## ADDENDUM #001

DATE: MAY 3, 2024

ELKHORN PUBLIC SCHOOLS  
ELKHORN HIGH SCHOOL  
AUDITORIUM RENOVATIONS  
1401 VETERANS DRIVE; ELKHORN, NEBRASKA 68022

JJA PROJECT: 3626  
DRAWINGS & SPECIFICATIONS  
DATED: 04/15/2024

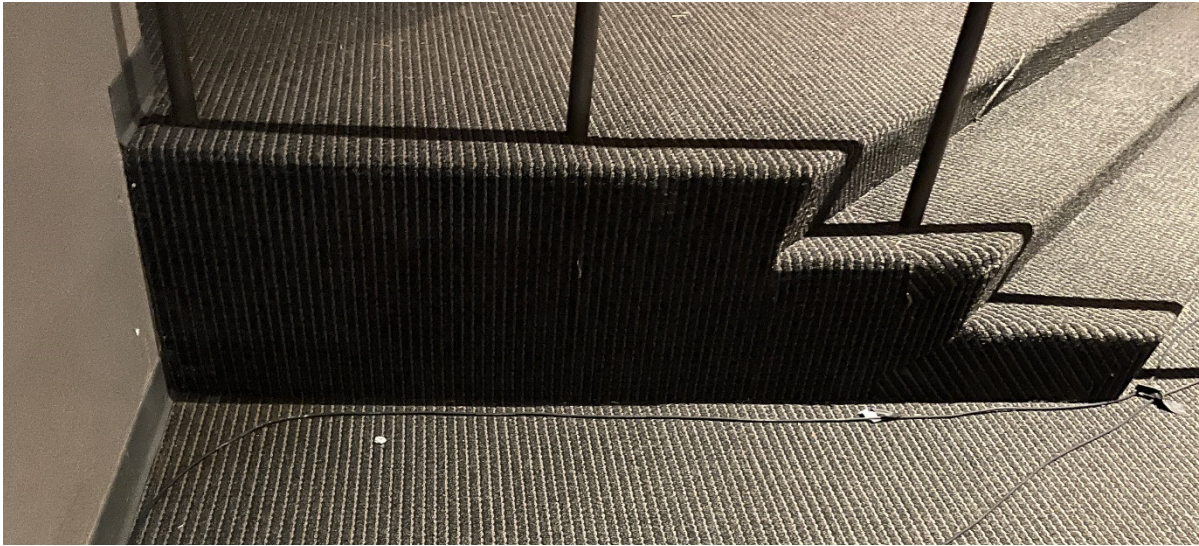
- A. Change carpet CPT-1: Shaw "Hand Drawn", Stipple Tile, #5T116
- B. Refer to the three (3) steps between Ex. Classroom A203 and Ex. Auditorium A215. The Risers on these stairs shall be carpet.
- C. Refer to Ex. Classroom A203 and Floor Finish Legend. As a matter of clarification, all of the stair risers, at the walk aisle and seating area are marked with "Yellow" and scheduled to have the step riser Tarkett/Johnsonite VR557X50.
- D. Refer to exterior door A215E at the southwest corner of Ex. Auditorium A215, and the below photo. Remove the carpet from the east side of the concrete risers, clean and prepare concrete as required to accept AC-1, Sto DecoCoat on the east vertical face.  
(See Photo on next page)

Photo “D” Remove existing pipe in its entirety and electrical cord.

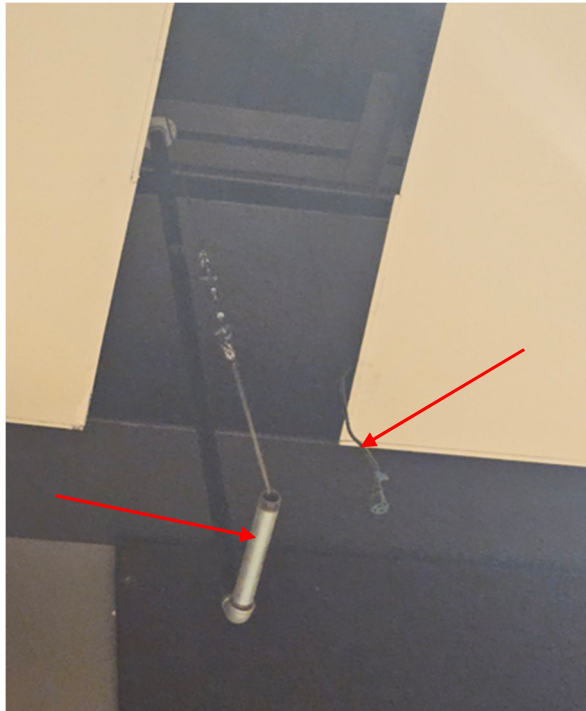
- A. Remove existing pipes and electrical cord at wall above stage as shown in photos “C” & “D” below.

1 LEVEL TWO FIRE PROTECTION FLOOR PLAN  
FP1.2 3/16" = 1'-0" 3' 6' 12' 18' 24'

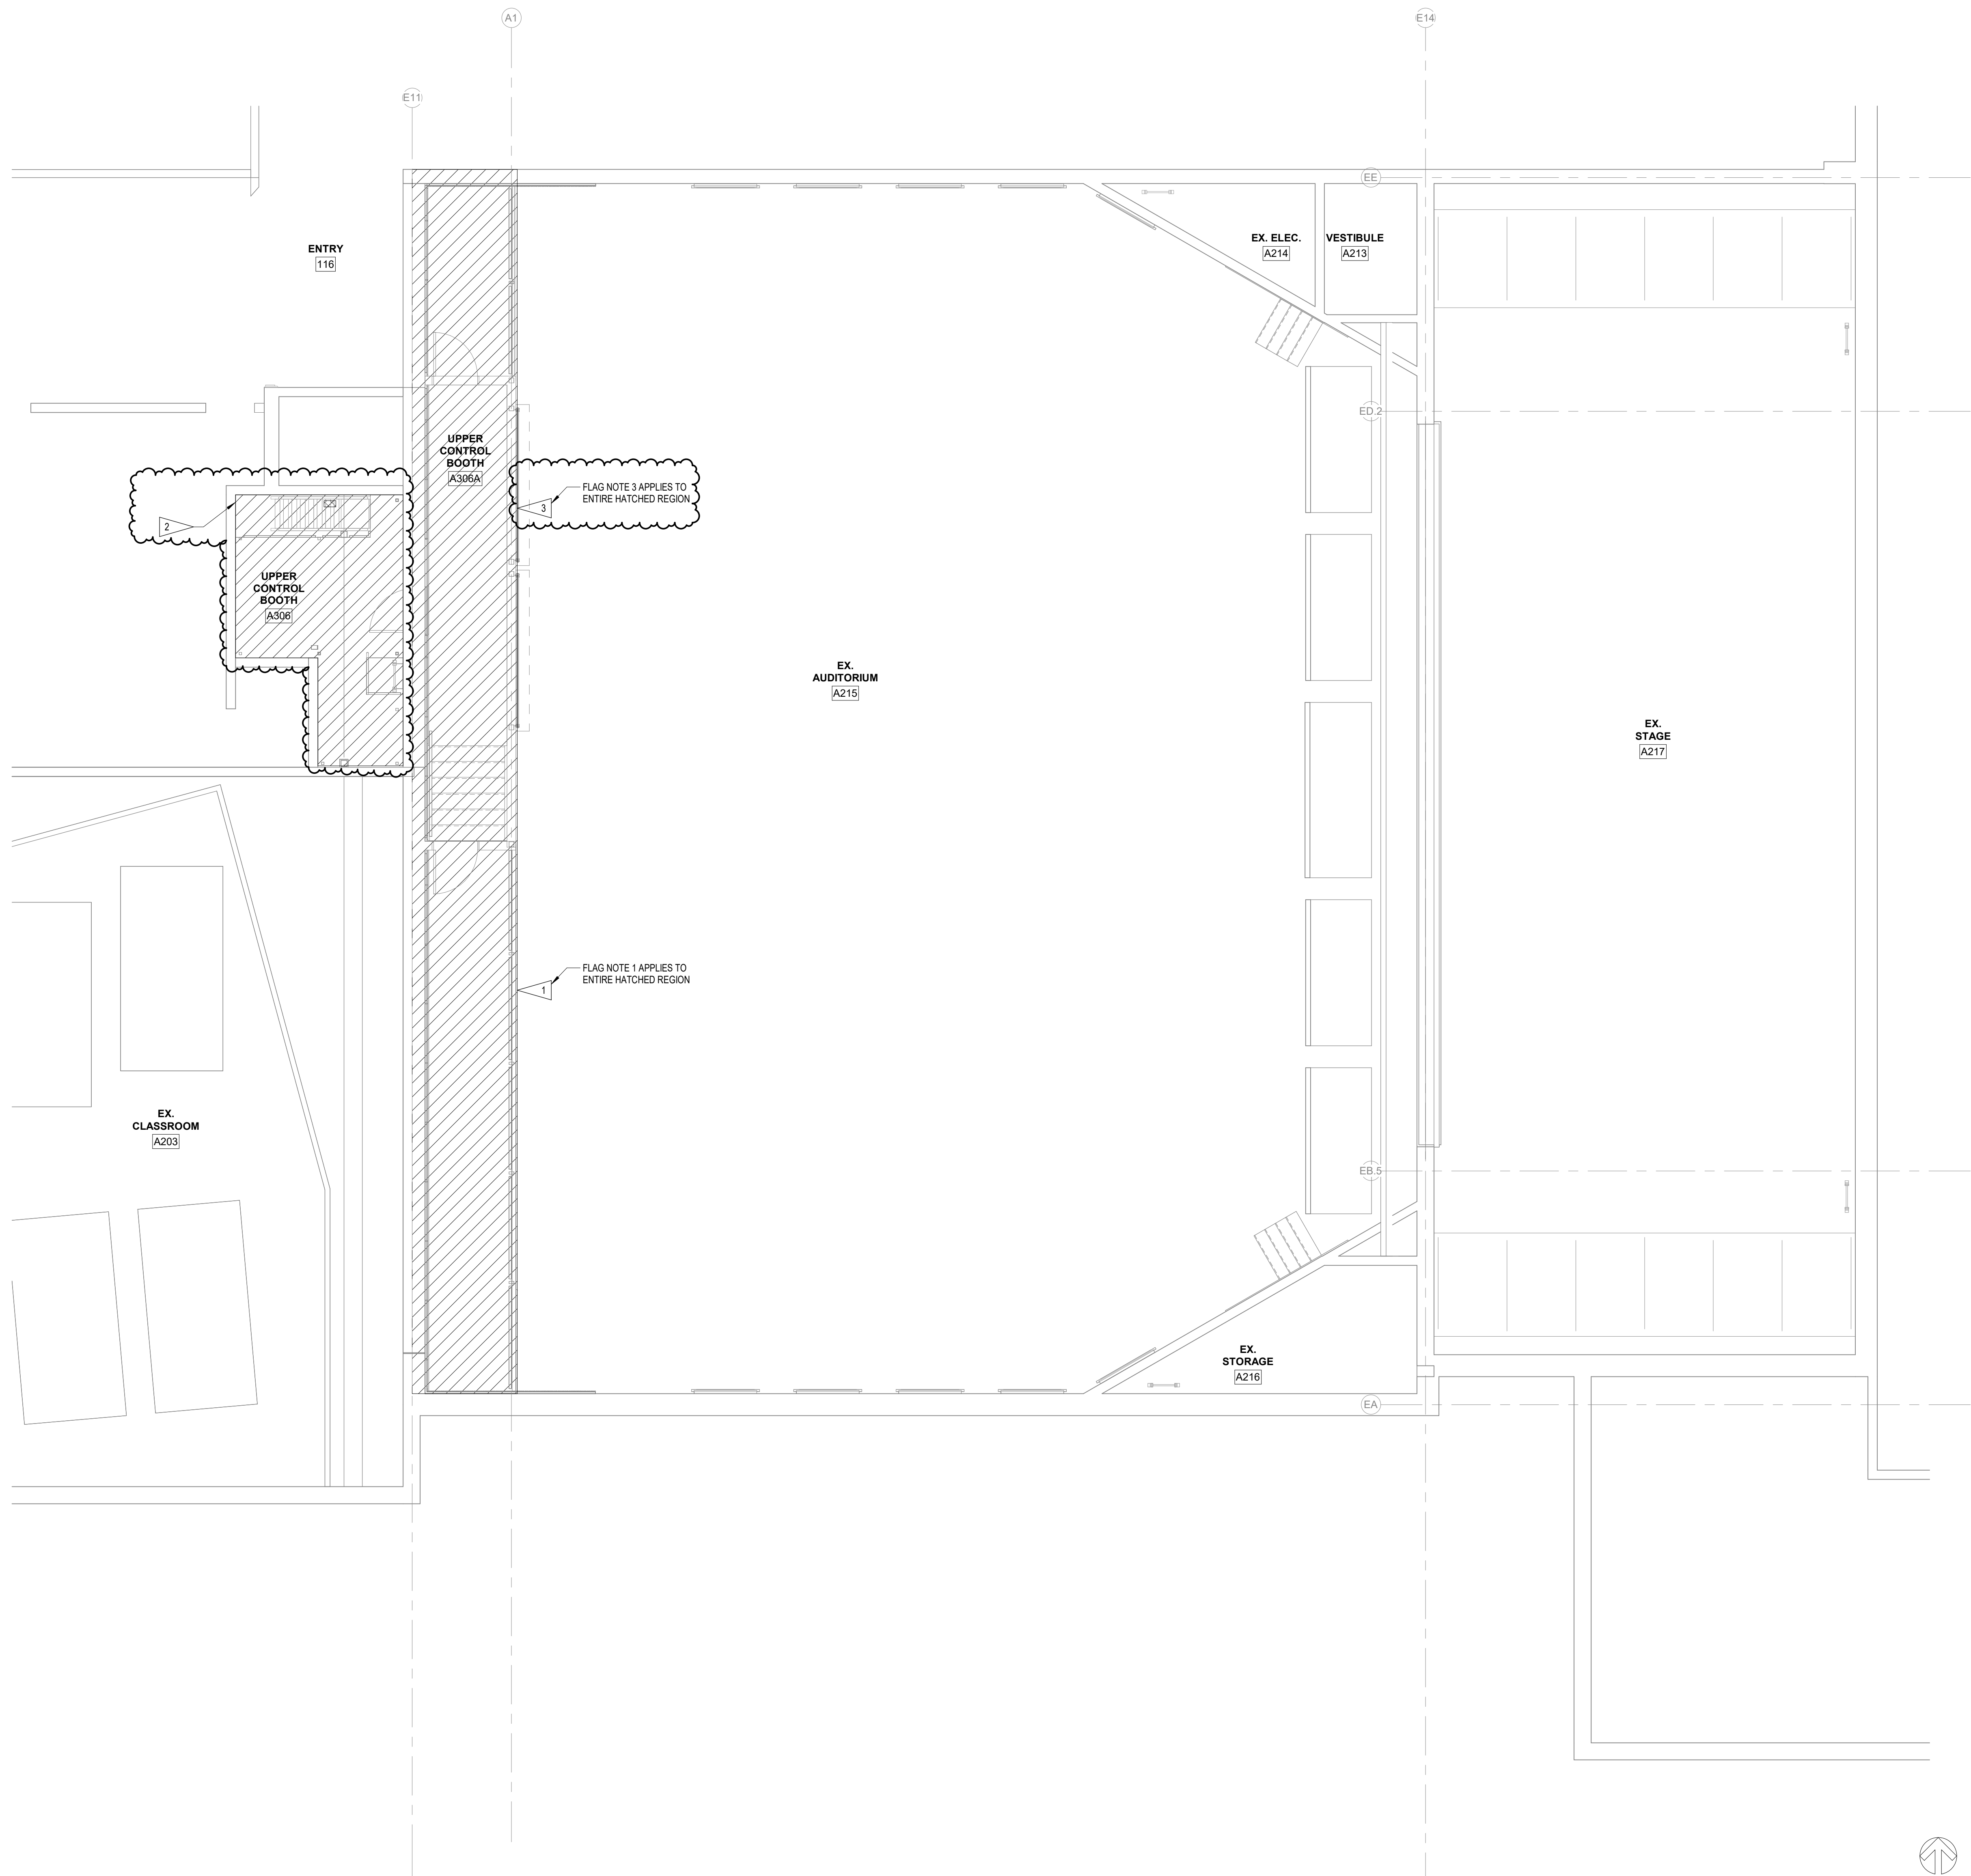
- Item #13**      Refer to Drawing FP1.2 – Level Two Floor Plan – Fire Protection and attached revised sheet.  
A. See revised flag notes and hatch regions detailing the necessary fire protection scope.

- 1 EXTEND SPRINKLER SYSTEM TO PROVIDE ADEQUATE COVERAGE BELOW NEW CATWALK. SYSTEM EXTENSION SHALL BE CONNECTED TO AUDITORIUM SIDE SYSTEM, IN LIEU OF THE CLASSROOM SYSTEM.
- 2 EXTEND SPRINKLER SYSTEM TO PROVIDE ADEQUATE COVERAGE IN UPPER CONTROL BOOTH A306. SYSTEM EXTENSION SHALL BE CONNECTED TO CLASSROOM SIDE SYSTEM.
- 3 EXTEND SPRINKLER SYSTEM TO PROVIDE ADEQUATE COVERAGE ABOVE NEW CATWALK. SYSTEM EXTENSION SHALL BE CONNECTED TO AUDITORIUM SIDE SYSTEM, IN LIEU OF THE CLASSROOM SYSTEM.

1	LEVEL ONE LIGHTING FLOOR PLAN
E1.0	$\frac{3}{16}" = 1'-0"$

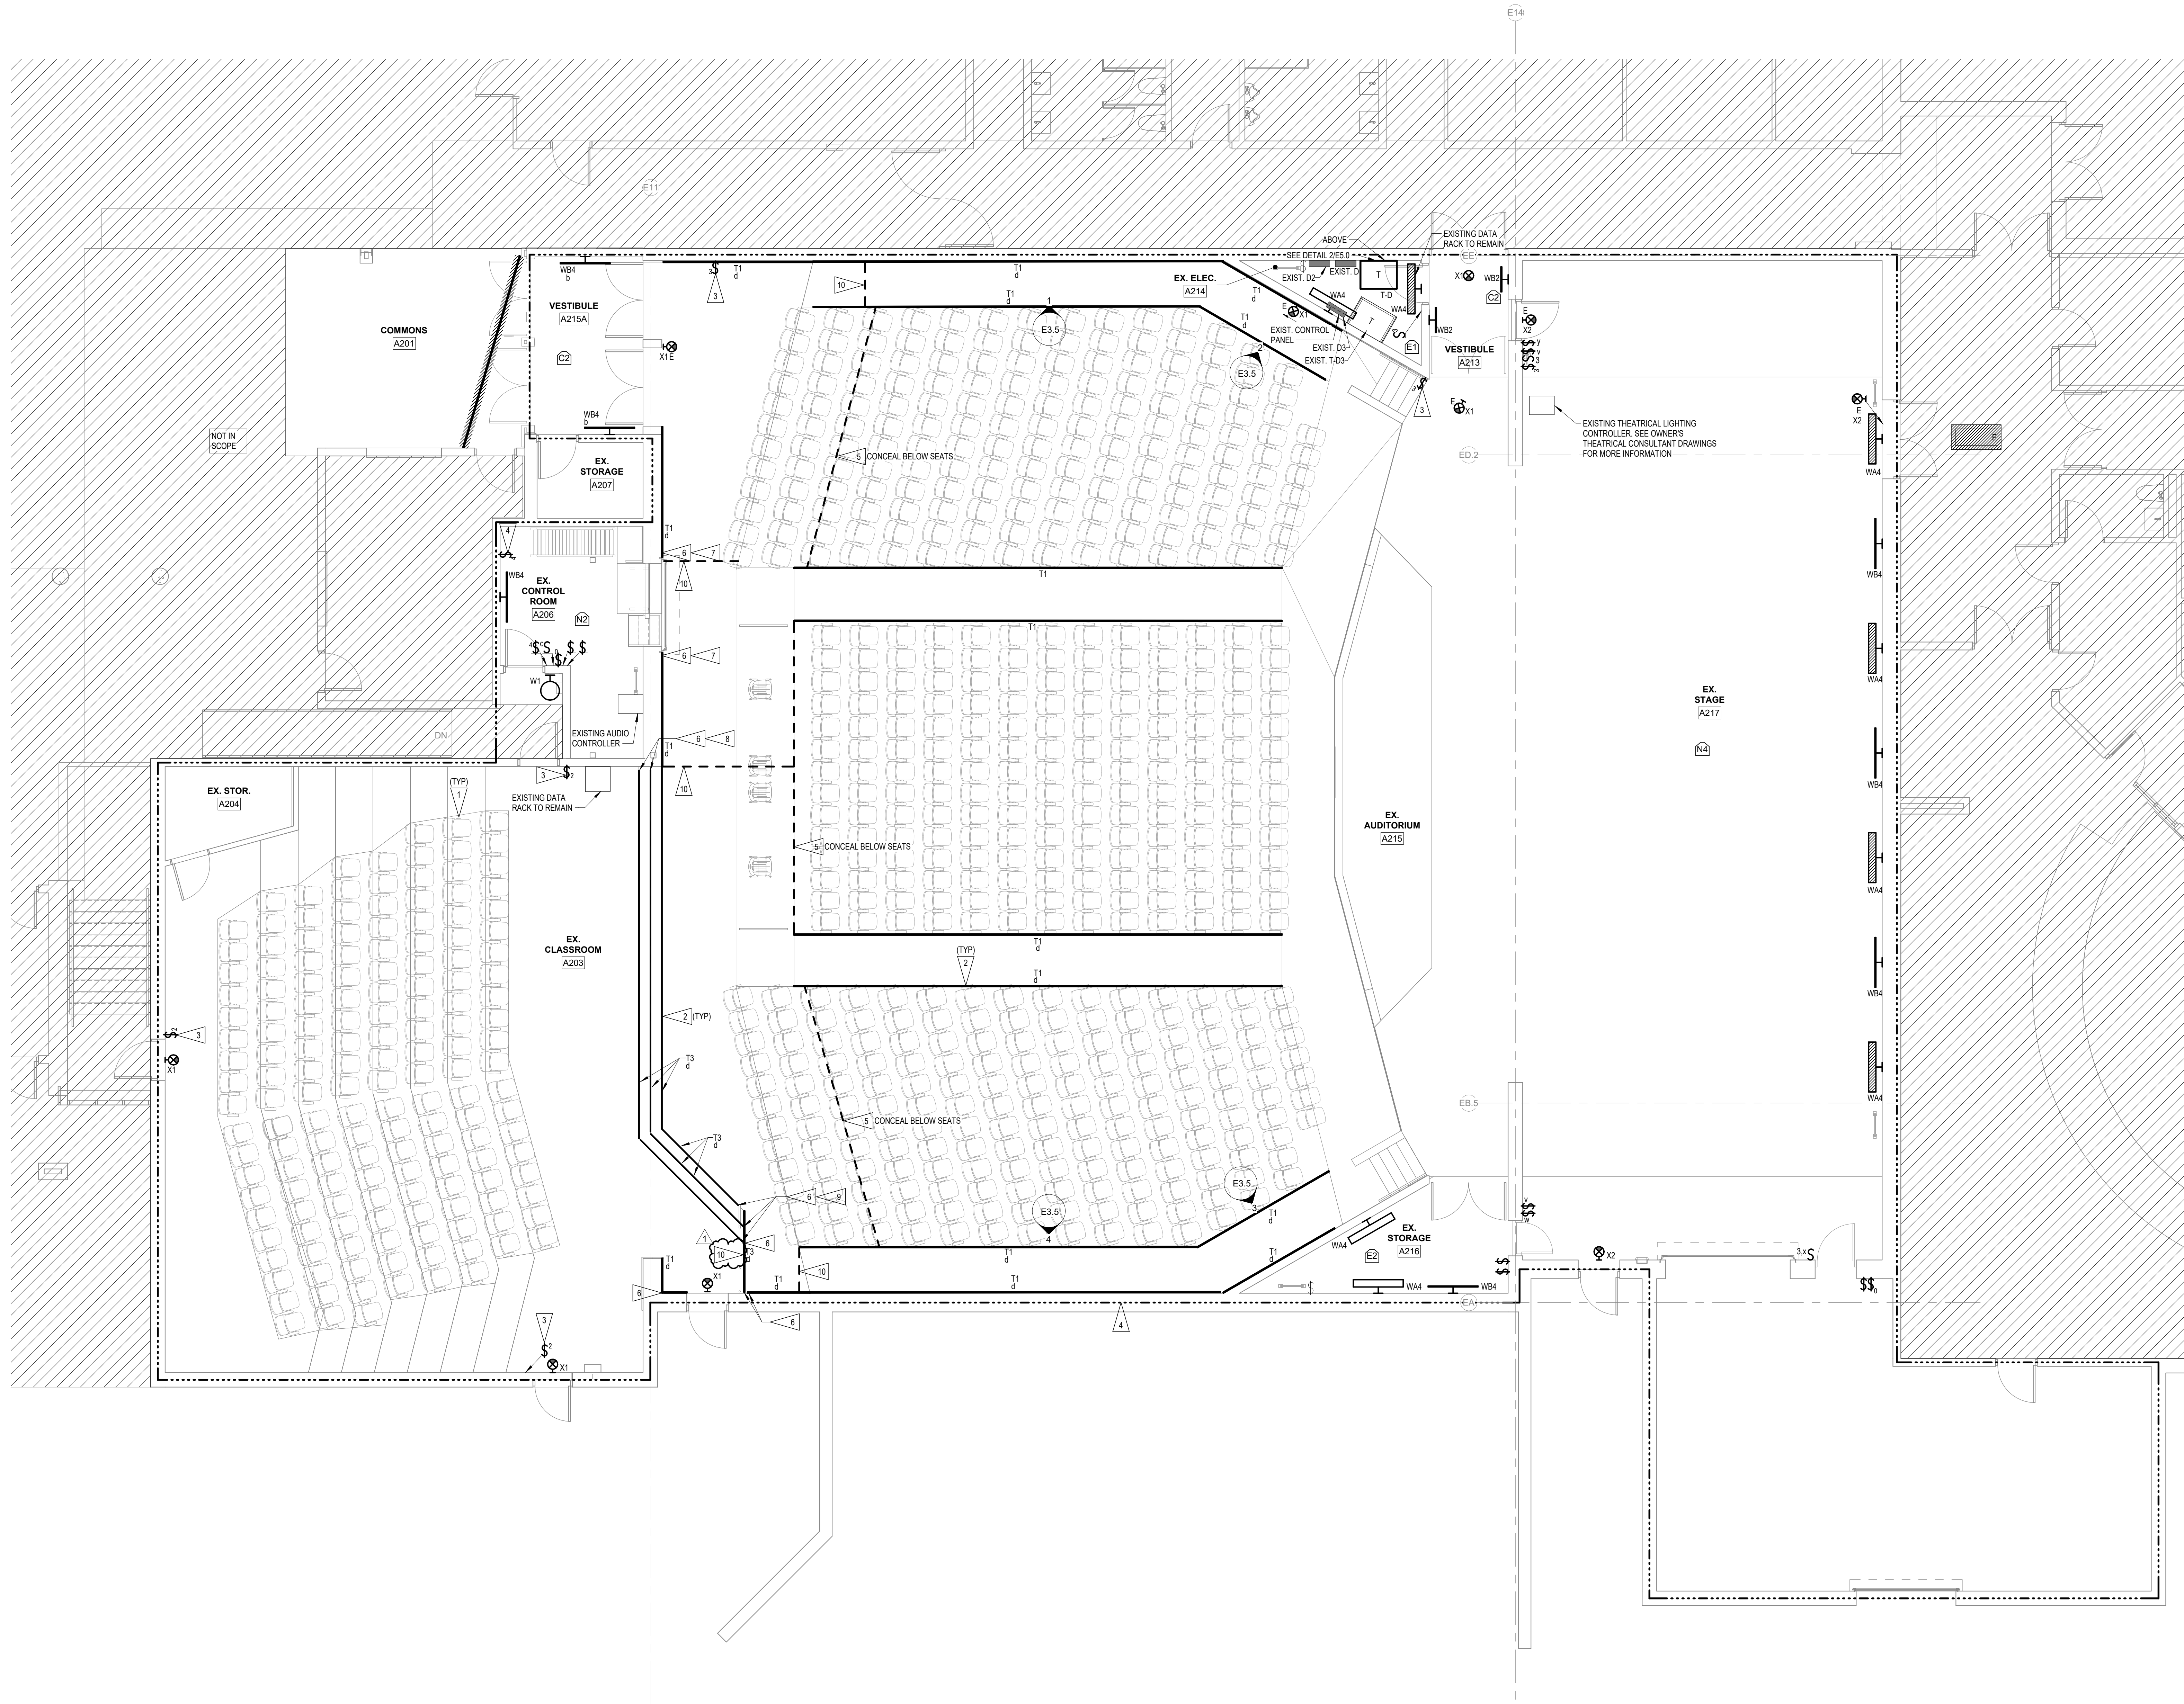
- Item #14**      Refer to Drawing E1.0 – Level One Lighting Floor Plan and attached revised sheet.  
A. ADD – Note to clarify mounting location of T3 fixture.
- Item #15**      Refer to Drawing E1.1 – Level One Lighting Reflected Ceiling Plan and attached revised sheet.  
A. REMOVE – Wall wash fixtures in existing hall.
- Item #16**      Refer to Drawing E2.2 – Level Two Power Floor Plan and attached revised sheet.  
A. REVISE – Callout for fire rated door closer.
- Item #17**      Refer to Drawing E6.0 – Electrical Schedules and attached revised sheet.  
A. ADD – Alternate manufacturers to luminaire schedule.
